WOLF CREEK

November 14, 2017
ET 17-0025

Subject: Docket No. 50-482: Response to Request for Additional Information Regarding License Amendment Request to Revise Technical Specifications to Transition to Westinghouse Core Design and Safety Analyses Including Adoption of Alternative Source Term

Response to Request for Additional Information

Figure 1: Simplified Control Room HVAC Diagram

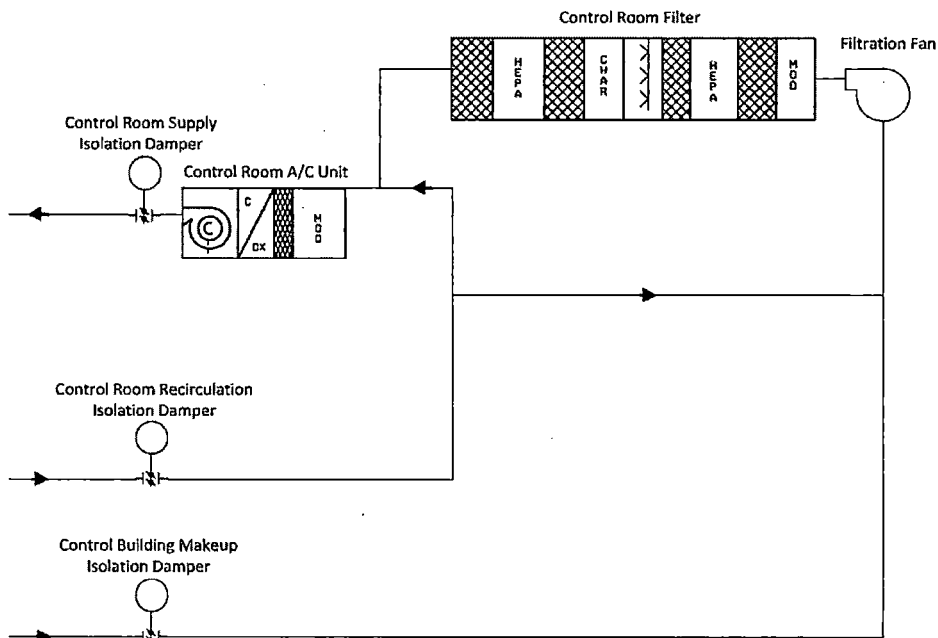
- b. *In the LAR, Enclosure VI, WCNOG explained that they will implement a design modification to supply the CREVS control room isolation dampers with battery power. WCNOG noted that this modification is necessary to support implementation of AST.*

Please describe the logic to isolate the CREVS. This description should include a discussion of how and when battery backed power will insure CREVS isolation.

Response: There are two CREVS control room isolation dampers per safety train. Each safety train has an isolation damper on the recirculation duct (coming from the control room) and on the supply duct (going to the control room). Makeup to the control room is from the control building. A simplified diagram of the control room HVAC system is provided in Figure 1.

The control room isolation dampers (labeled as Control Room Supply Isolation Damper and Control Room Recirculation Isolation Damper in Figure 1) are interlocked with the Control Room A/C Unit. Thus, if the Control Room A/C Unit is running, the two dampers are open. Likewise, if the Control Room A/C is off, the dampers are closed. The dampers are interlocked only with the Control Room A/C unit and there is no additional control for the dampers.

In order to eliminate the requirement to dispatch a local operator, the design modification will change the control room isolation damper's power supply to safety-related battery power during all modes of operation. In order to support the modification, the battery load calculations have been assessed to ensure adequate battery load is available to support the planned modification. The control circuitry will not be changed. Thus, if a single failure, such as the failure of a filtration fan, were to occur in a CREVS train following an accident, the control room operators will have the capability to isolate the affected CREVS train from the control room by turning off the corresponding Control Room A/C Unit. Likewise, for the case where power is lost to the Control Room A/C Unit, such as a loss of the associated EDG, the isolation dampers will automatically close since they will receive a signal to close (interlocked with the Control Room A/C Unit) and they will be supplied with safety-related battery power.
